**Status: Final**  
February 10, 2021

**Reference # 13516.101.L2.Rev1\_Goderich Shoreline Slope Grading**  
**RE: GODERICH - SHORELINE SLOPE GRADING**

Figure 2: Goderich South Community area of proposed bluff regrading (highlighted by green shading)

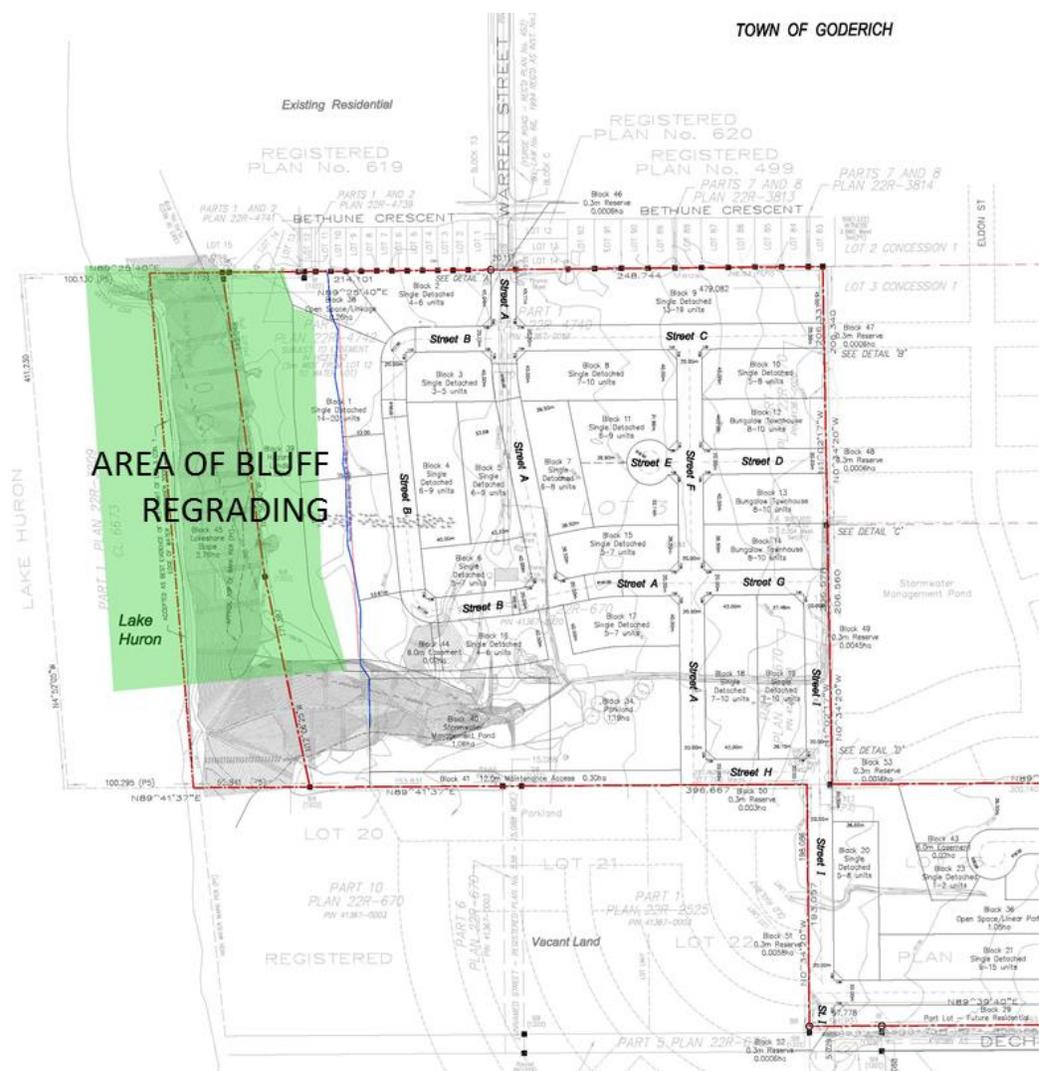
The area of the bluff regrading is shown in Figure 2. A typical section of the proposed bluff regrading plan, including a trail, is presented in Figure 3. Based on the existing 1:1.9 slope and the stable slope of 1:2.8, it is estimated that about 460 m<sup>3</sup>/m of bluff material would be excavated from the upper slope and placed at the water’s edge at the toe; the existing toe of slope would be covered but otherwise undisturbed. It should be noted that the regrading of the native material to the toe of the bluff does not permit altering the shoreline erosion hazard allowance determination based on the existing location of the toe of bluff slope.

Figure 3: Typical bluff section, showing proposed regrading plan

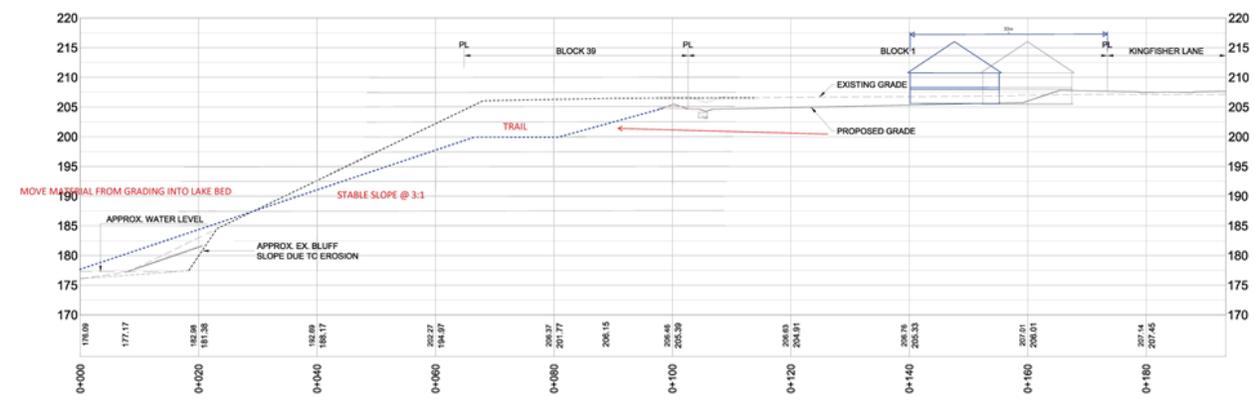
The native material to be placed at the toe is material that would have, over time, naturally fallen into the lake as the bluff retreated. At an average annual recession rate of 0.25 m/year, about 7.3 m<sup>3</sup>/year of bluff material would slump from the 29 m high bluff down to the shore where the available wave energy would readily move the finer-grained portion offshore and sand and gravel portion along the shore, in the net direction towards the south.
